Replacing plate bay door hinges and gas struts (FCO CA04191)

☑ Trendsetter Autoloader
☑ Trendsetter NEWS

Locked ball coupling:

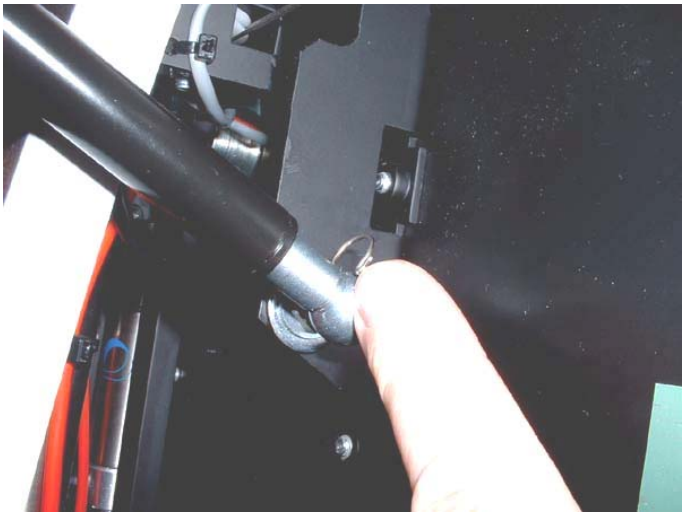
1. The new gas struts for the door have a new socket for the ball stud in the plate bay.
   Unlock the plastic ball coupling on the gas strut using a small screw driver to pull up the locking mechanism.
